## REVISED RESPONSE TO REQUEST FOR ADDITIONAL INFORMATION

### APR1400 Design Certification

RAI No.: 161-7992

SRP Section: 09.01.04 – LIGHT LOAD HANDLING SYSTEM AND REFUELING  
CAVITY DESIGN

< Figure 1 Configuration of Refueling Pool Seal Assembly >

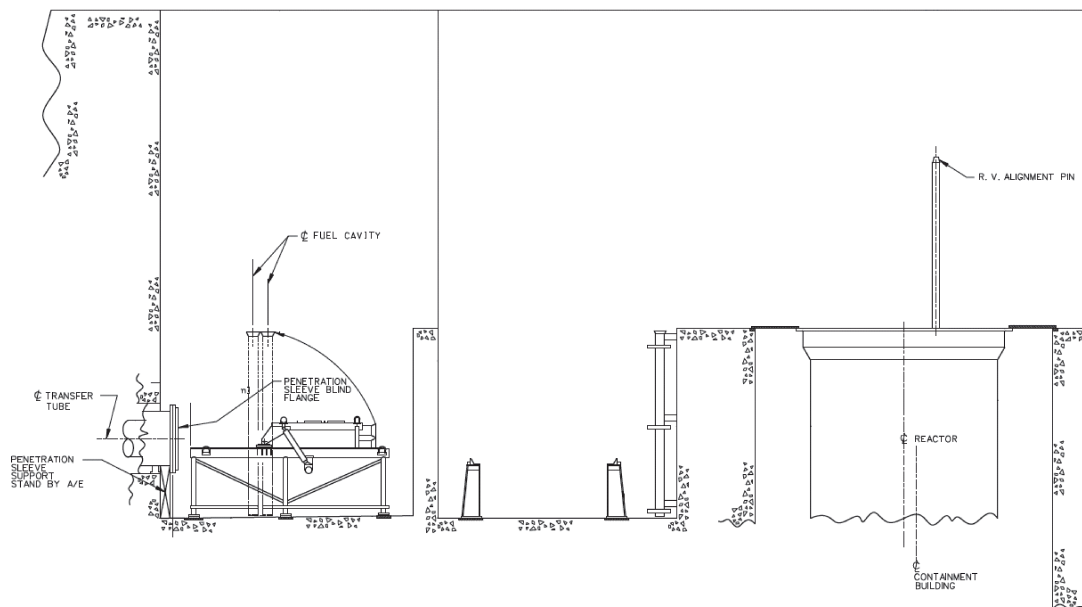
- a. NUREG-0800, SRP 9.1.4.III.3.D.i states that the refueling cavity should be provided with a robust refueling cavity water seal that is built to appropriate engineering codes, or manufacturing association standards, will not catastrophically fail during a seismic event, and is not vulnerable to a single failure (passive or active) that results in a gross failure that significantly affects the refueling cavity water level.

The staff noted that the refueling cavity seal has been classified as Seismic category II component. DCD, Tier 2 Section 3.2.1, "Seismic Classification," defines seismic category II as "designed to preclude a gross structural failure resulting from an SSE that could degrade the ability of an adjacent safety-related SSC to function to an unacceptable level or result in incapacitating injuries to personnel in the main control room (MCR)." This definition does not preclude the seal from failing and draining the refueling cavity.

Therefore, the staff requests the applicant to upgrade the seismic design of the refueling cavity seal to seismic category I, or to provide a justification as to how the seal design prevents a failure that significantly affects the refueling cavity water level.

The refueling pool seal is a steel structure. The refueling pool seal consists of several components, such as seal plate, inner and outer supports, rib plates and inner and outer flexures (refer to Figure 1). These components are made of stainless steel plates and continuously welded together. The refueling pool seal is designed to permanently seal the annulus between the reactor vessel seal ledge and the embedment ring in the refueling pool floor.

According to the definition of seismic category II which is designed to preclude a gross structural failure resulting from an SSE, the potential leakage through the refueling pool seal is considered even though the refueling pool seal maintains its structural integrity. The assumed leakage path may be a crack on the structure or weld failure which would cause negligible leakage.

When the refueling pool seal is initially installed, its welds are non-destructively inspected to confirm that there are no weld deficiencies. Therefore, the probability of leakage through the refueling pool seal is very low. If leakage occurs through the refueling pool seal, the operator

can readily identify the leakage by monitoring various water level instruments. Then, the operator can take the appropriate actions to add makeup water to the refueling pool inventory. As a result, the refueling pool water level can be maintained to have sufficient inventory. Therefore, the seismic category II classification of the refueling pool seal as non-safety equipment satisfies the related regulation requirements, such as NUREG-8000. But, to ensure that the refueling pool water level is not affected by a failure, KHNP will upgrade the seismic class of the refueling pool seal to seismic category I for this design certification.

Figure 9.1.4-15 Refueling Pool Seal

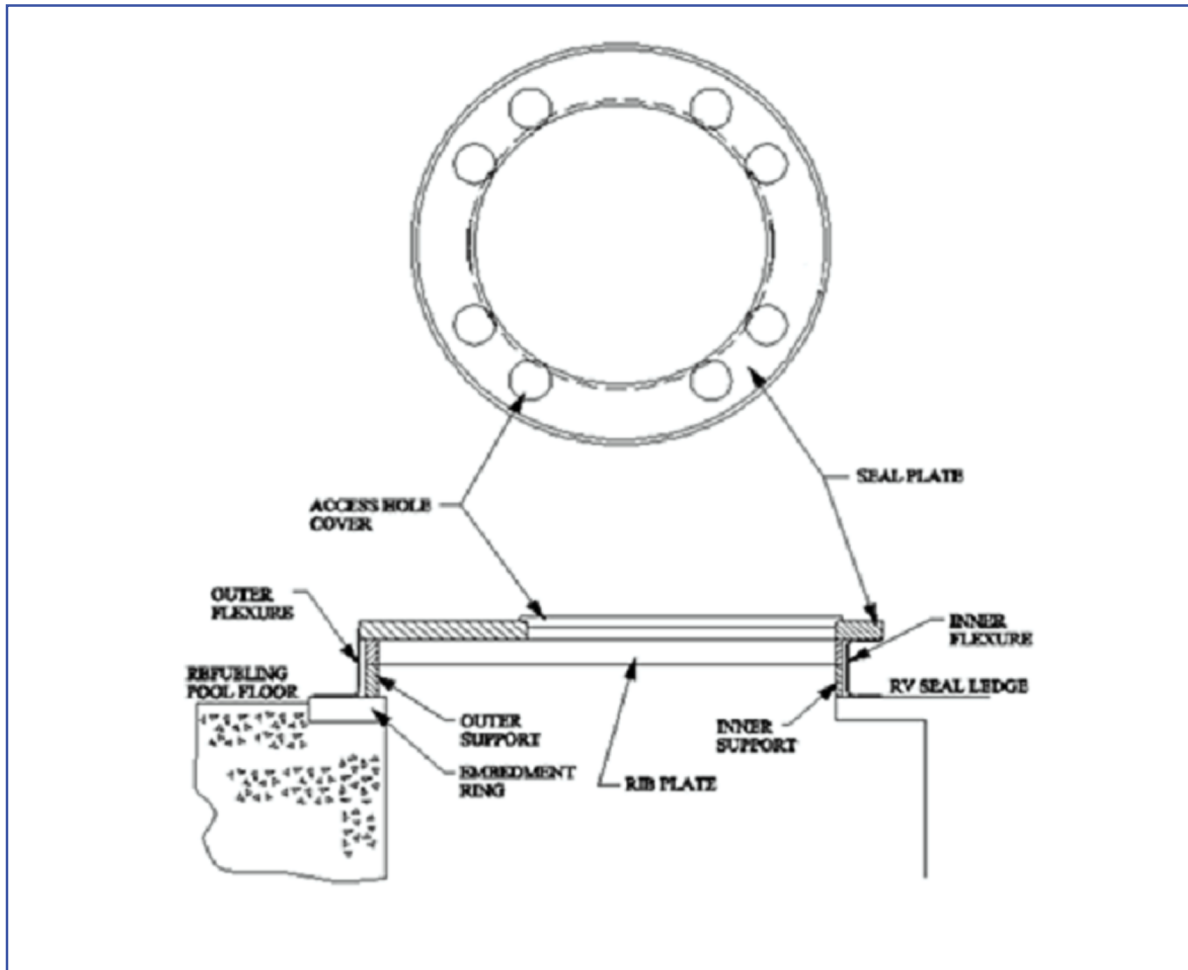
- d. DCD Tier 2 Table 3.2-1 describes the refueling pool seal as NNS. The applicant provided the safety class definitions in DCD Tier 2 Section 3.2.3.

The staff finds that the refueling pool seal provides assurance of required cooling for the fuel temporarily stored in the cavity (upender); therefore, the refueling pool seal meets the definition of Safety Class 3 (SC-3).

Therefore, the staff requests the applicant to reclassify the refueling pool seal as a SC-3 or to provide justification for retaining the NNS classification.

#### 9.1.4.2.1.11 Refueling Pool Seal

The refueling pool seal, as shown in Figure 9.1.4-15,

The refueling pool seal is designed to connect the RV seal ledge to the embedment ring in the refueling cavity floor to permit filling of the refueling cavity for fuel handling activities. During normal refueling operations, the pool seal is designed to withstand the pressure resulting from a water head that is the full depth of the refueling cavity from the elevation of the operating floor. Pool seal welds required for structural integrity or sealing integrity are inspectable. The openings for ex-core detector servicing and inspection and for cavity ventilation are designed to permit pressure testing to verify their integrity before filling with the refueling water. The pool seal is designed for the impact of a fuel assembly drop from the maximum height. Transfer of heavy loads over the RV is prohibited during fuel handling operations. Therefore, the drop of such loads is not considered credible in the design of the pool seal. The COL applicant is to provide plant procedures for preventing and mitigating inadvertent reactor cavity drain down events, maintenance procedures for the maintenance and inspection of refueling pool seal, and emergency response procedures for the proper measures during pool drain down events (COL 9.1 (4)).
